Re: Response to Clarification Questions

Request for Information ("RFI") from Israel Independent System Operator ("NOGA")

regarding the Transmission of Submarine Electrical Energy

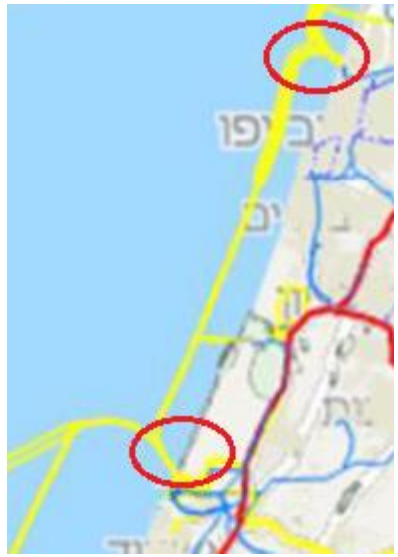
kV and 161 kV) in the requested service?	
4	Annex 1, § 2.1.2.1	We understand that NOGA is considering here a submarine transmission system as part of a future development of the network meshing, and not as a solution to connect offshore windfarms for example. Please confirm the purpose of this submarine transmission system.	Confirmed
5	Annex 1, § 2.1.2.4	A transmission capacity of 900 MW would need two circuits in parallel. Please confirm this power capacity for the requested services.	Confirmed
6	Annex 1, § 2.1.3	We understand that the submarine transmission lines would be located between the identified landing points in §2.2, and within a 10 km width corridor from the coastline. Please confirm.	Confirmed. Also, please note that according to Section 4, the statutorily strip should be 3km from Israeli coast line
7	Annex 1, § 2.2	Except for the identified power plants, the other landing points are difficult to locate (particularly for Sorek and Morasha). Would you have coordinates?	Please see the map below. Morasha is located in the northern circle and Sorek is in the southern
